**MADERA UNIFIED  
SCHOOL DISTRICT**  
1902 Howard Road  
Madera CA 93637  
(559) 675-4500  
(559) 675-1186 Fax  
[www.madera.k12.ca.us](http://www.madera.k12.ca.us)

Addendum No. 1-Bid Section 1-5  
Asphalt Resurface & Repairs at Various School Sites  
BID No. 033116

This Addendum is attached to and made a part of the above entitled specifications for Madera Unified School District for BID No. 033116 with a due date of May 5, 2016

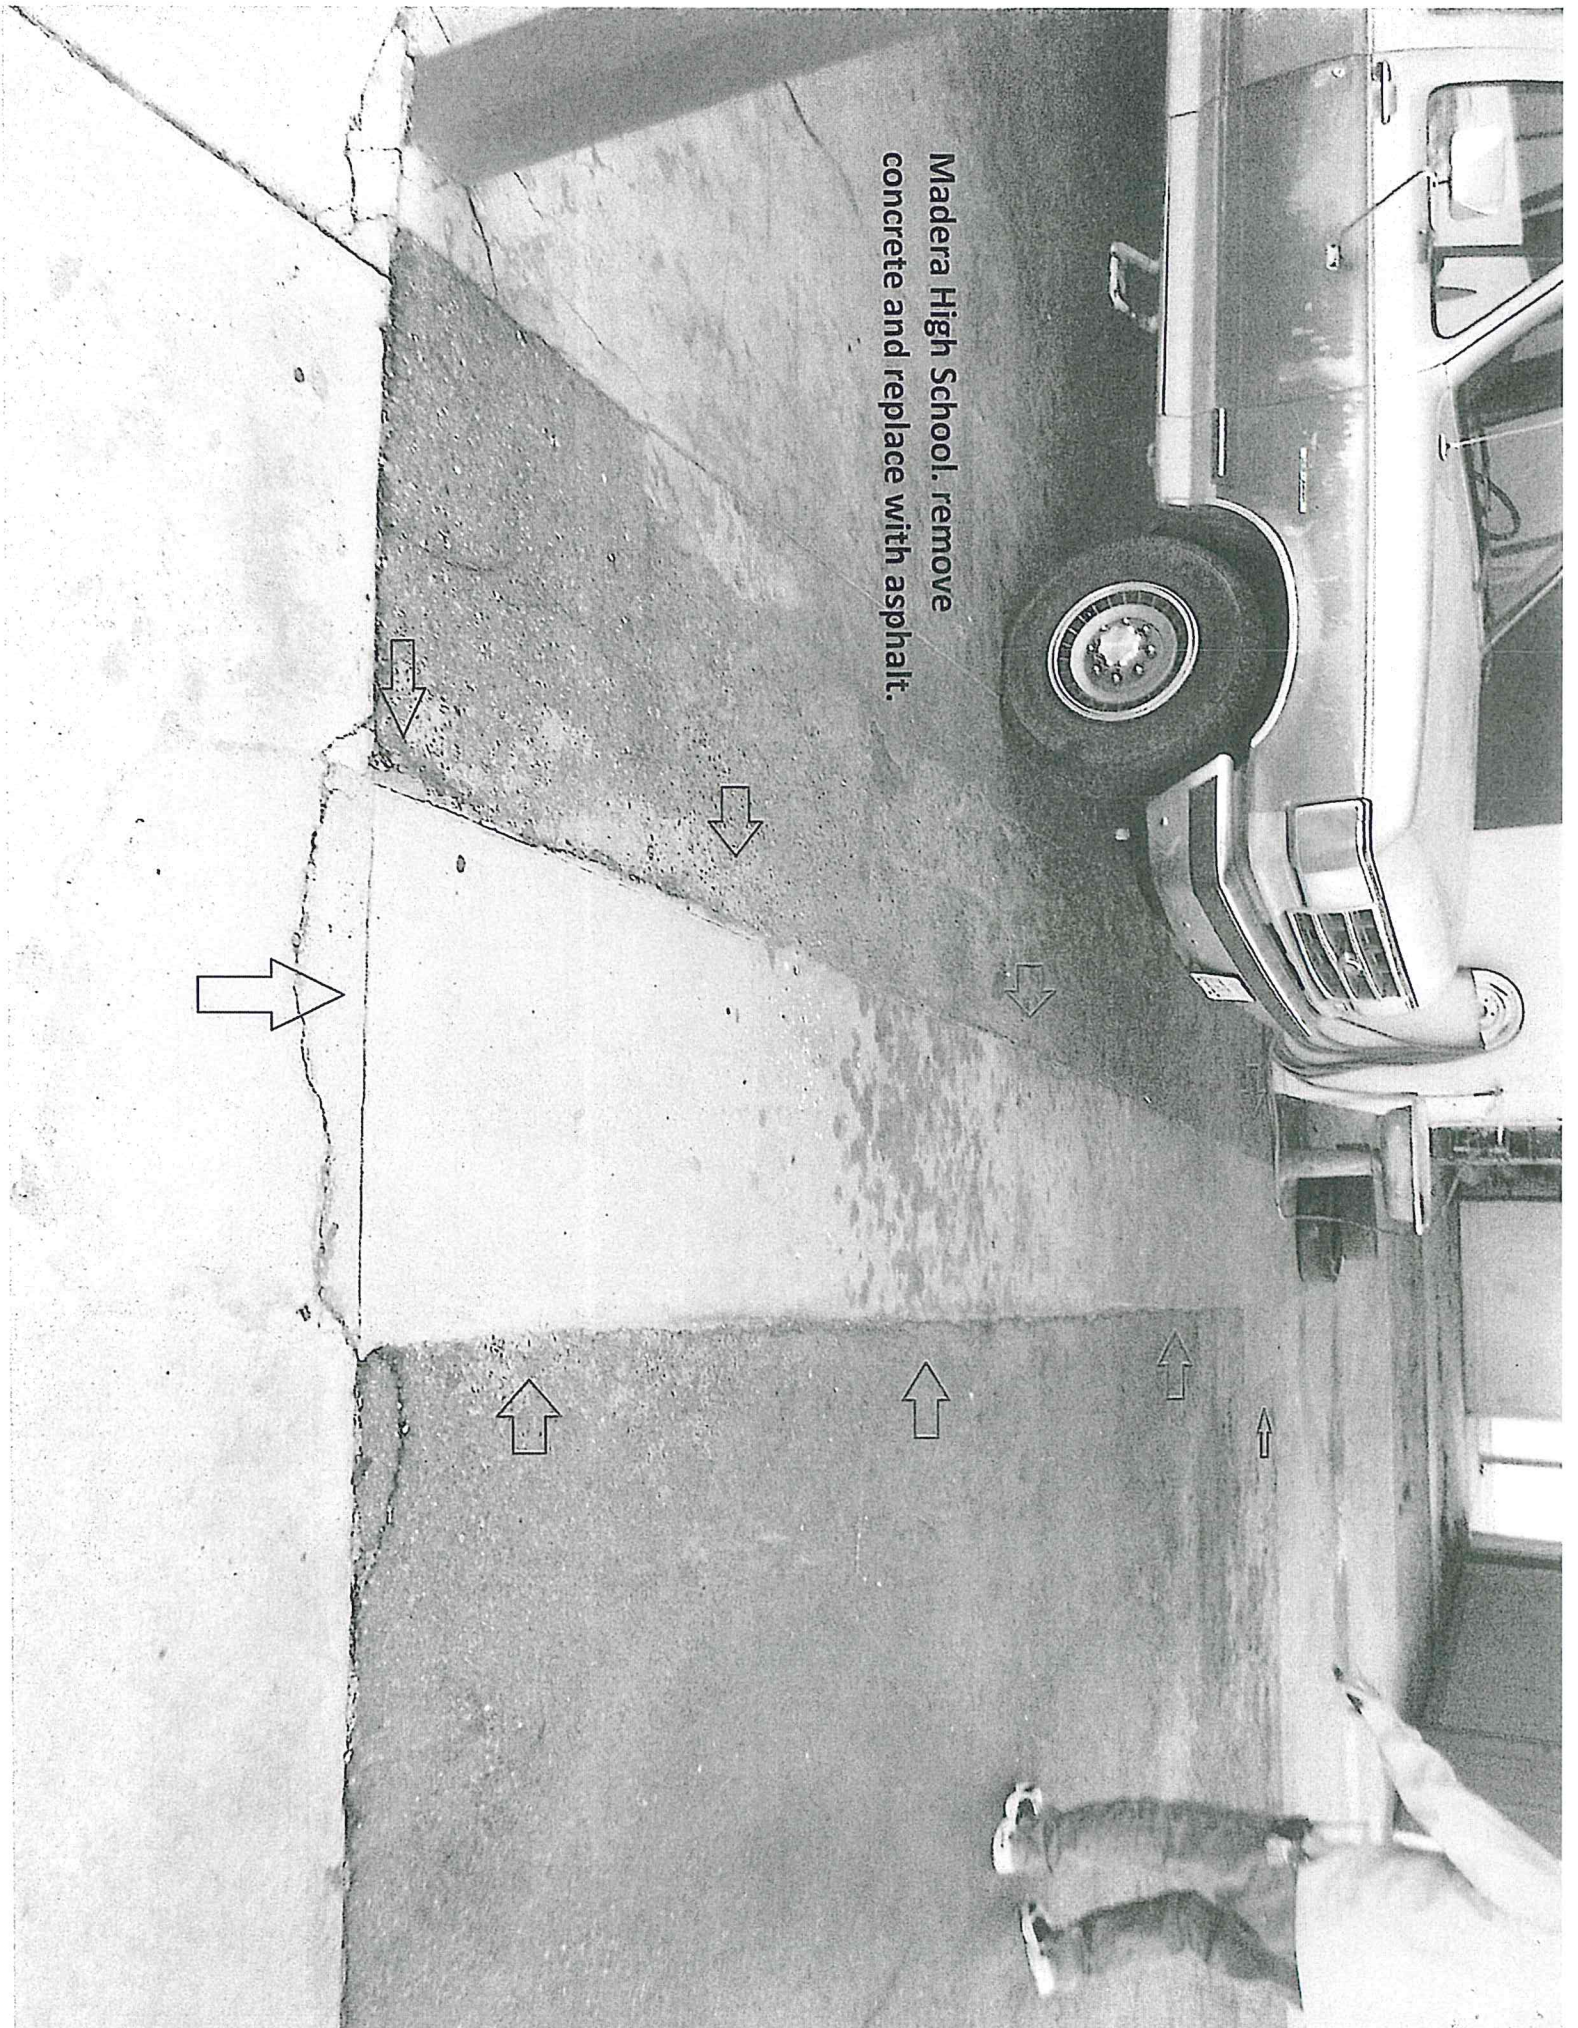
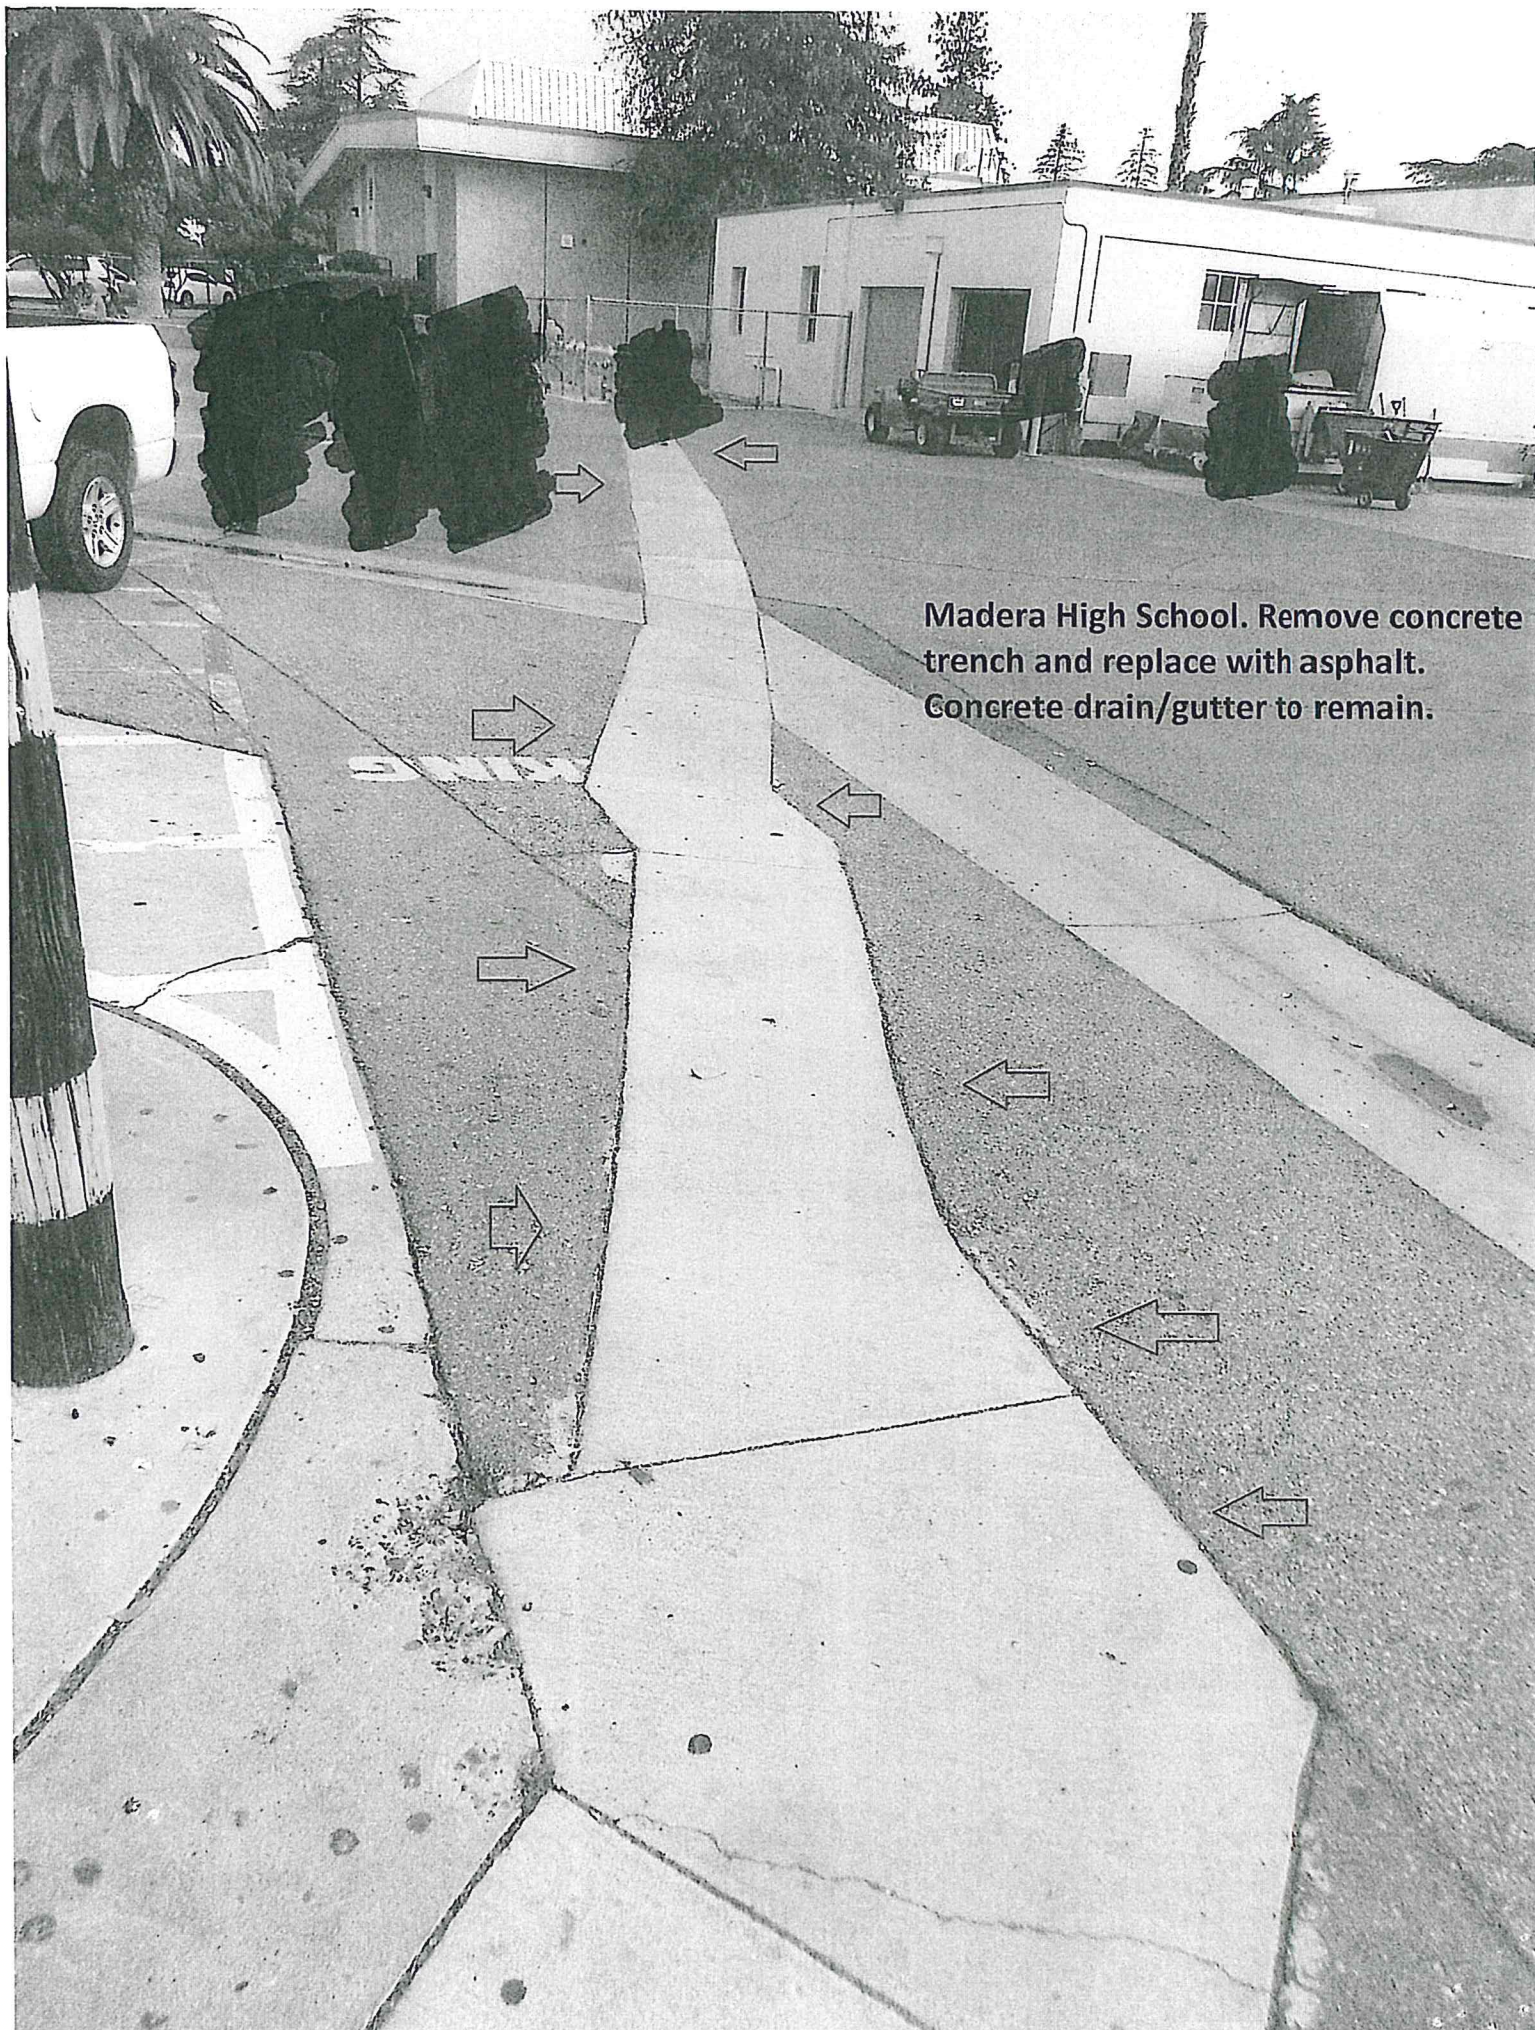
Madera High School. Remove existing concrete and replace with asphalt.

Madera High School. remove  
concrete and replace with asphalt.
